ECN/PCN No.: M1385

Product Description: Molded Power Inductor	Abrakon Part Number / Part Series: ASPI-0520LR Series	<input type="checkbox"/> Documentation only <input checked="" type="checkbox"/> ECN <input type="checkbox"/> EOL	<input checked="" type="checkbox"/> Series <input type="checkbox"/> Part Number(s)
Affected Revision: A	New Revision: B	Application:	<input type="checkbox"/> Safety <input checked="" type="checkbox"/> Non-Safety

7.0 Mechanical Dimension

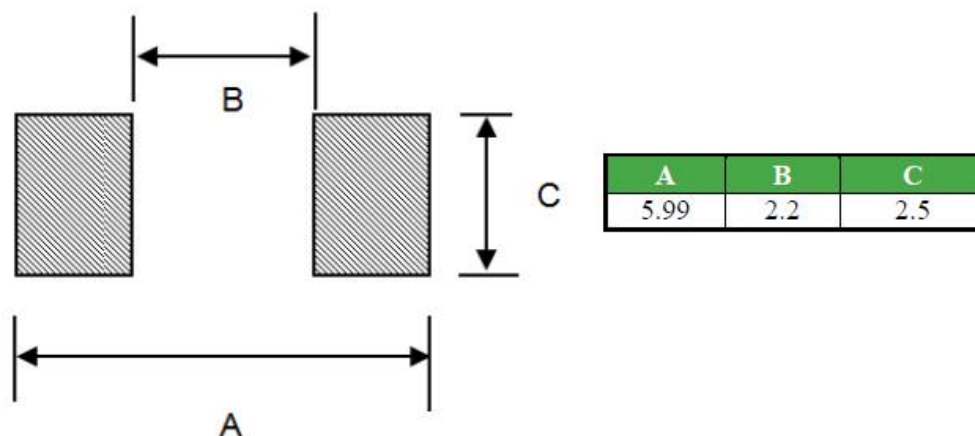
Prior to Change:

A	A'	B	B'	L	W	H
1.0 ±0.4	1.5 ±0.1	2.0 ±0.3	2.5 ±0.2	5.60 ±0.35	5.2 ±0.2	2.0 ±0.1

Pad Analysis for the original recommended PCB pad layout and the inductors electrodes.

Inductor electrodes height:	2.0	PCB footprint pads height:	2.5
Inductor electrodes length:	5.6	PCB footprint pads length:	6
Inductor electrodes gap:	2.6	PCB footprint pads gap:	2.2
Enter a Scaling Value:	3	Dimensions [mm]	
<small>(Adjust value to zoom in or out, i.e 1.00, 0.5, 3.5, etc)</small>

Mechanical Specifications

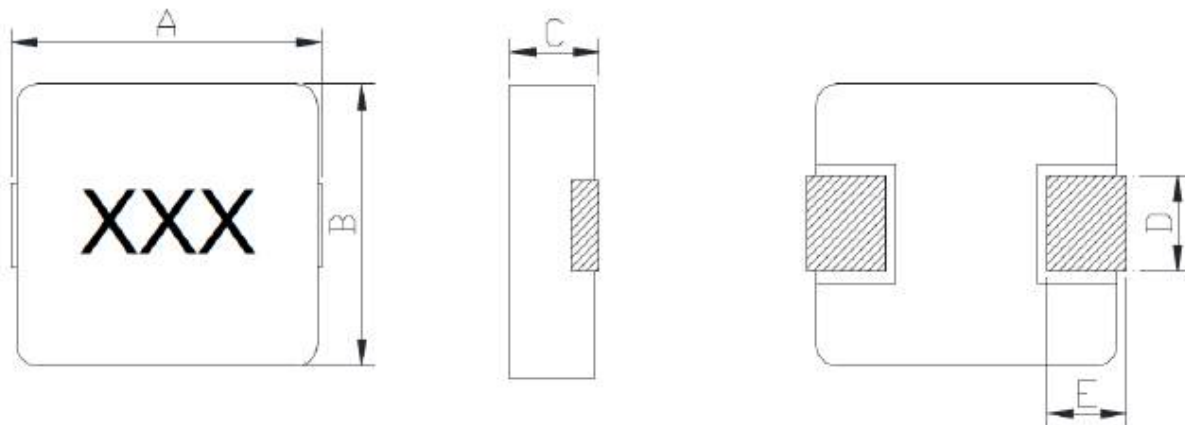
After Change:

A	B	C	D	E
5.7 ±0.3	5.3 ±0.4	2.1 MAX	2.0 ±0.5	1.2 ±0.5

The overall mechanical outline has changed slightly. More importantly, the recommended pad layout has changed. Design engineers must review and ensure new pad dimensions are permissible. Please review the included pad dimension analysis illustrations.

Recommended Layout

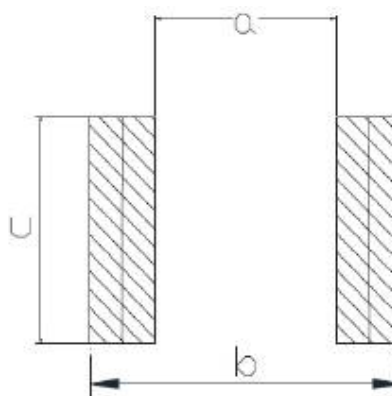
a	b	c
3.0 TYP	7.0 TYP	2.5 TYP

Pad Analysis for the original recommended PCB pad layout and the inductors electrodes of the updated package.

Inductor electrodes height: <input type="text" value="2.0"/> Inductor electrodes length: <input type="text" value="5.7"/> Inductor electrodes gap: <input type="text" value="3.3"/> Enter a Scaling Value: <input type="text" value="3"/> <small>(Adjust value to zoom in or out, i.e 1.00, 0.5, 3.5, etc)</small>	PCB footprint pads height: <input type="text" value="2.5"/> PCB footprint pads length: <input type="text" value="6"/> PCB footprint pads gap: <input type="text" value="2.2"/> Dimensions [mm]
--	---
